RECEIPT DATE: 12/18/12 **ONSITE SEWAGE DISPOSAL SYSTEM** P 544458

PROPERTY ADDRESS: 14850 Meriwether Drive  
 SUBDIVISION: Meriwether Farm LOT: 38 TAX ID: 04-593679  
 CONTRACTOR: Fogles Septic Clean Inc. EMAIL: kurt@foglesinc.com  
 CONTRACTOR ADDRESS: 580 Obrecht Road, Sykesville, MD 21784 PHONE: 410-795-5670  
 PROPERTY OWNER: Toll MD VIII LP EMAIL: \_\_\_\_\_  
 OWNER ADDRESS: 7164 Columbia Gateway Drive, Columbia, MD 21046 PHONE: 410-992-5878

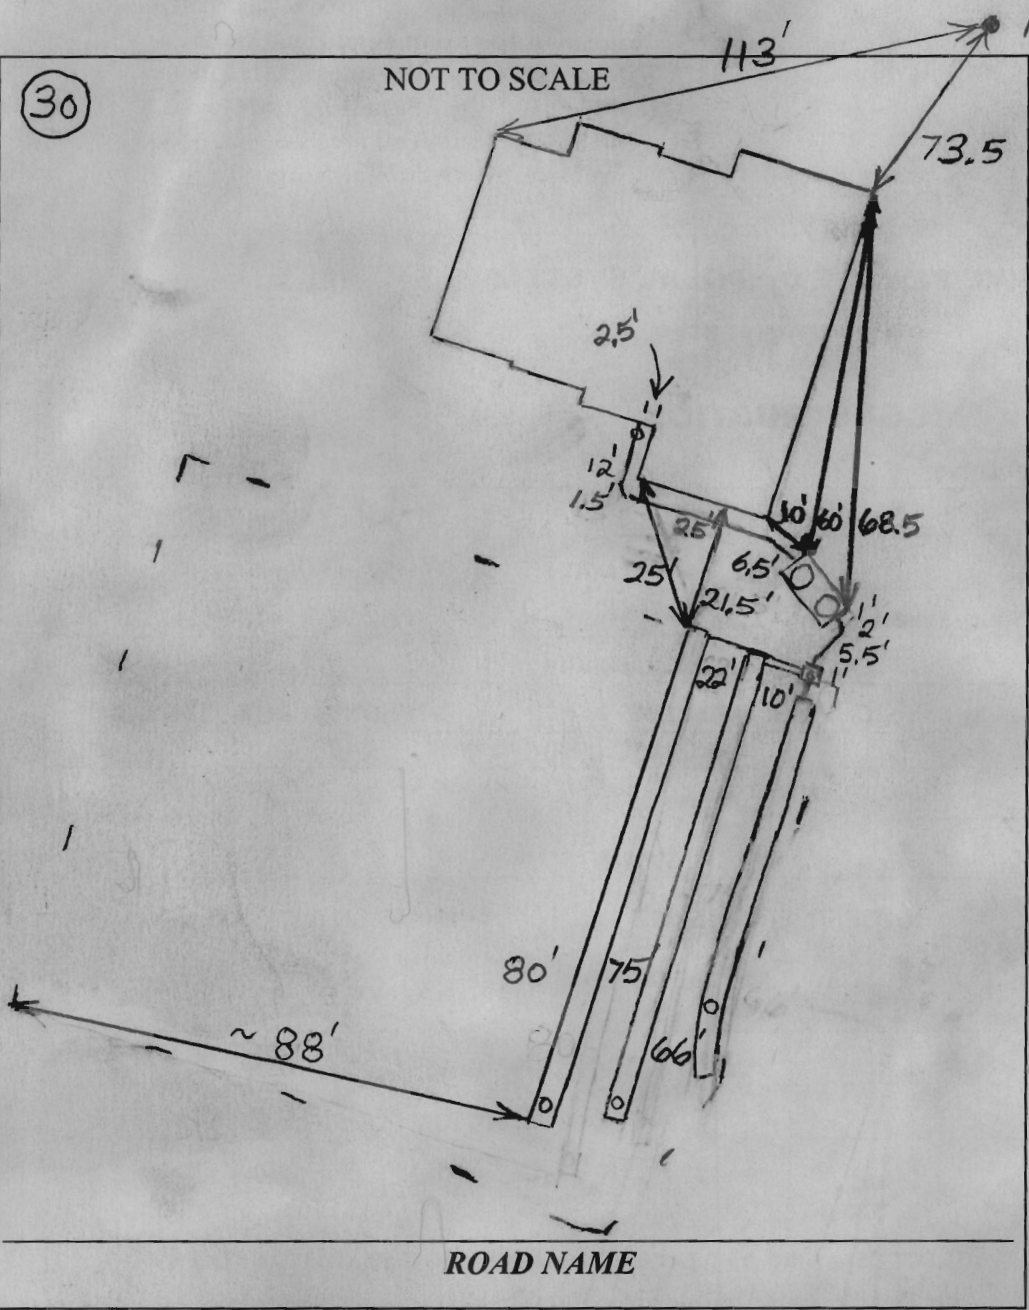
TRENCHES:	LINEAR FEET REQUIRED: <u><del>210</del> 225'</u>	INLET DEPTH: <u>4</u> ✓
	TRENCH WIDTH: <u>3</u> ✓	MAXIMUM BOTTOM DEPTH: <u>6</u> OK
	MINIMUM SPACE BETWEEN TRENCHES: <u>9</u>	EFFECTIVE AREA BEGINNING DEPTH: <u>5</u>
LOCATION:	PER APPROVED SITE PLAN. SEWAGE DISPOSAL AREA AND BAT UNIT LOCATION MUST BE STAKED BY LICENSED SURVEYOR PRIOR TO PRE-CONSTRUCTION INSPECTION.	
NOTES:	Set septic tank per plan. Set distribution box per layout inspection. Install 3 x 70' trenches on contour in upper reserve area.

PRE-CONSTRUCTION:

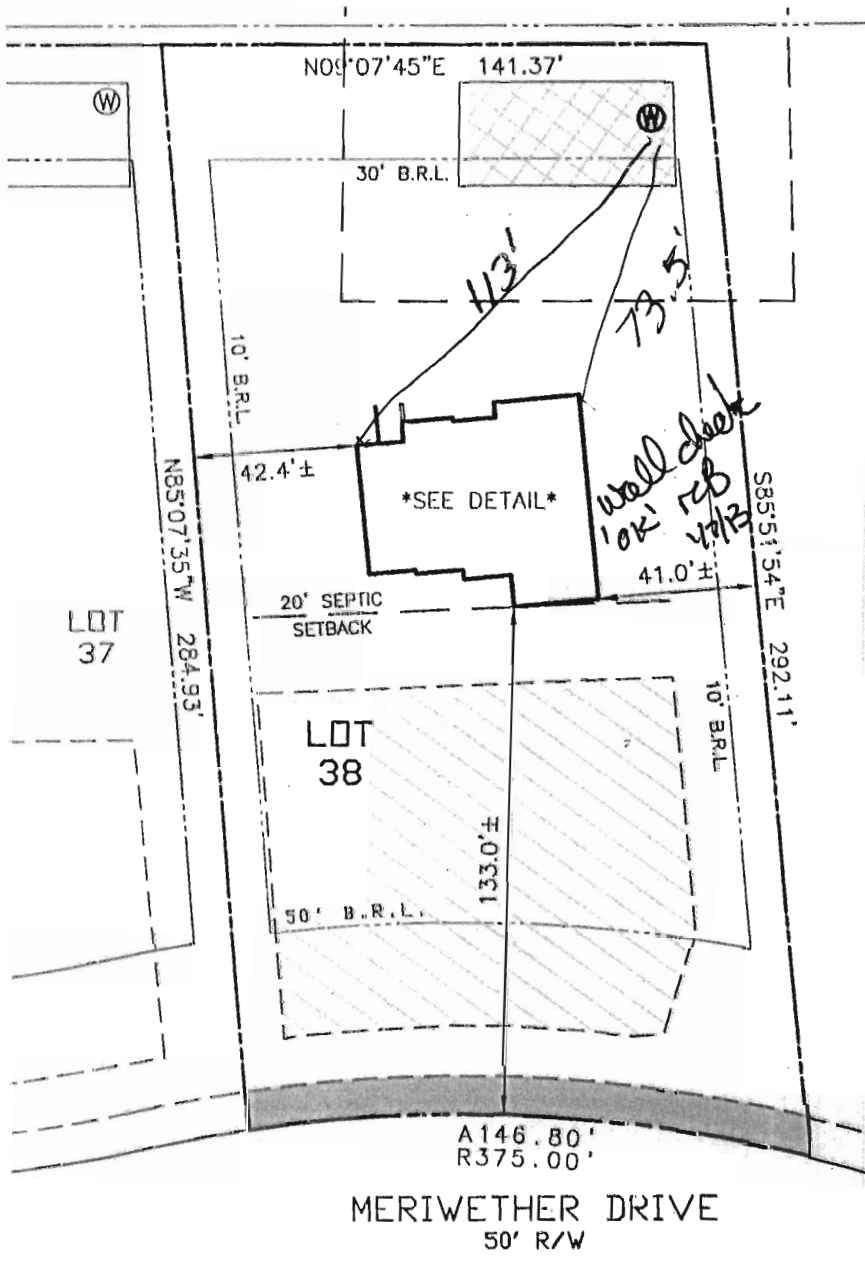
1/22/2013 Layout not done. Frozen fill on easement. (BB)

2/8/12 Wet, sloppy conditions. Not sure if sewer is hung or cut. Will probably not make basement gravity service. Too deep for jacks. OK to set tank 10' from garage (beverage on pad foundation). Set D box top corner of SEA on 3 inches on contour towards road parallel w/ proposed drive. Top trench = 65', middle trench 75', lower trench 85'.
